IOWA DEPARTMENT OF TRANSPORTATION

TO OFFICE: District 1	DATE: 4/9/2020
ATTENTION: District Engineer	REF.: Jasper
FROM: Ray Ringgenberg	Project # IMX-080-5(343)174—0E-50
OFFICE: District 1 Design	PIN:16-50-080-020
SUBJECT: Field Exam Review (D-2)

HMA RESURFACING WITH MILLING

IMX-080-5(343)174--OE-50

EB Bridge
Maint.#-5079.8R080
FHWA# - 31270
Design# - 1760
(Strip seal glands should be replaced)

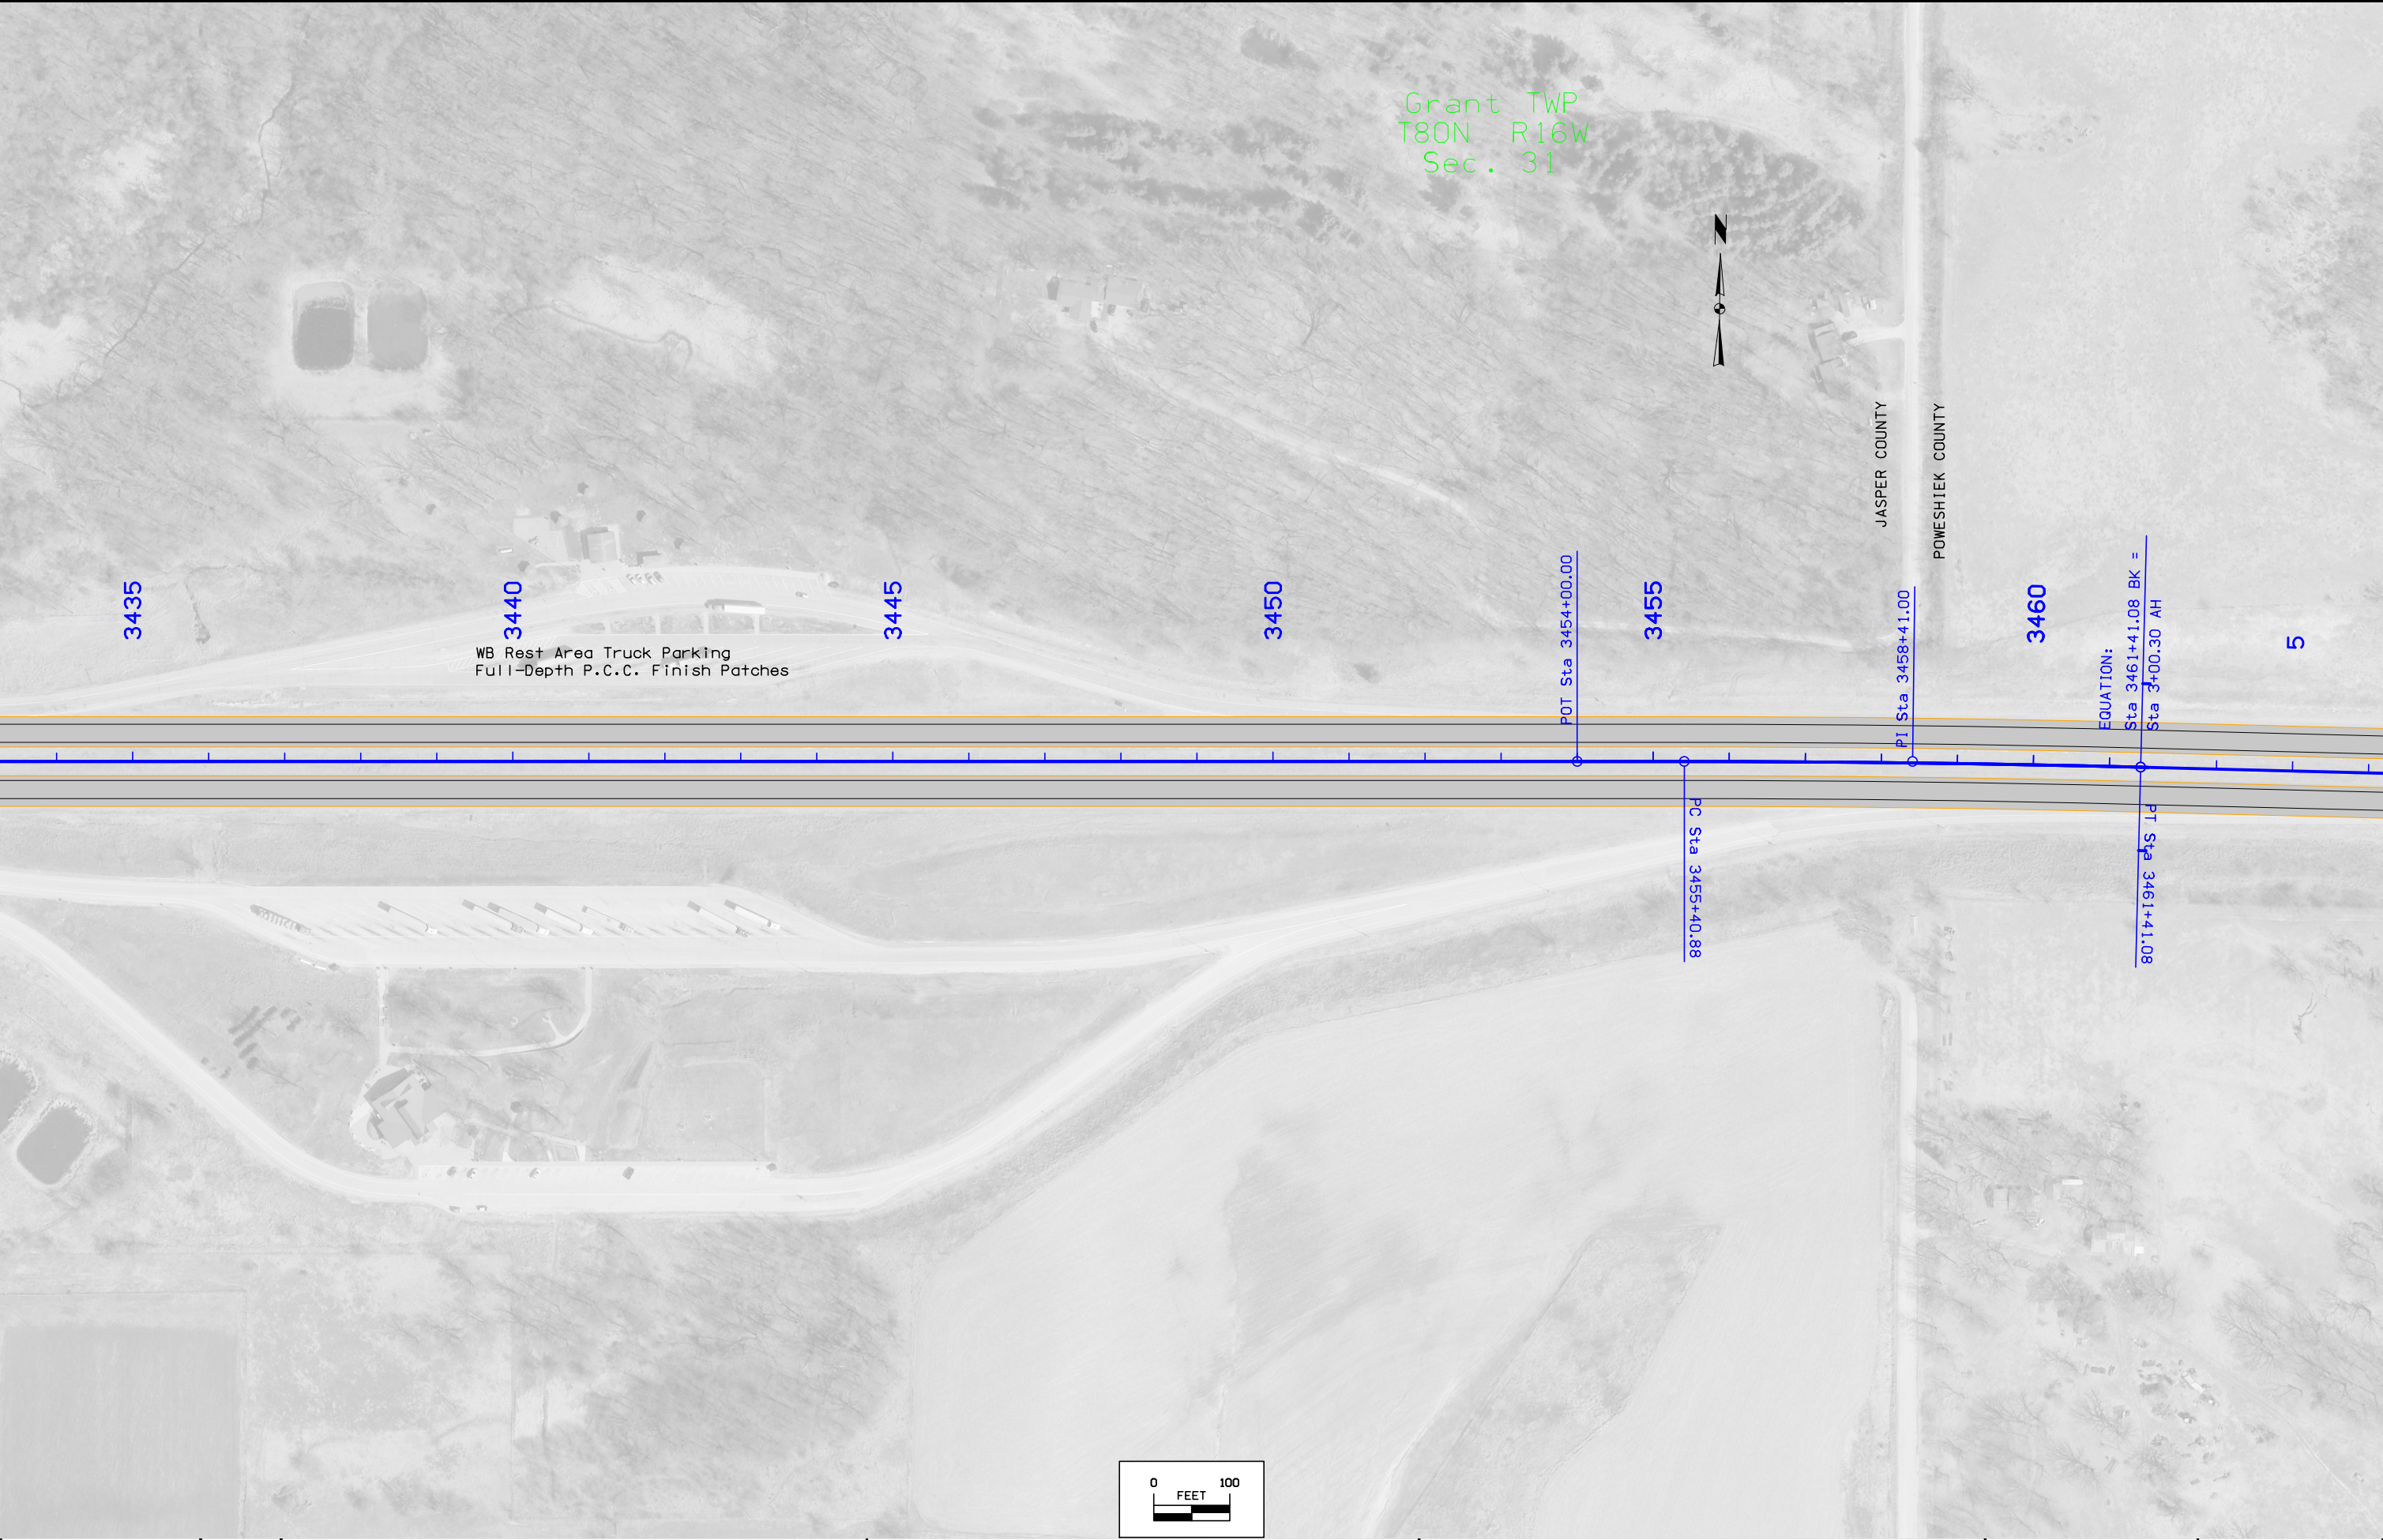
WB Bridge
Maint.#-5079.8L080
FHWA# - 31280
Design# - 1760
(update guardrail
West end strip seal extrusion
is serverly damaged. Replacement
of joint is needed. Replace strip
seal gland at east end joint)
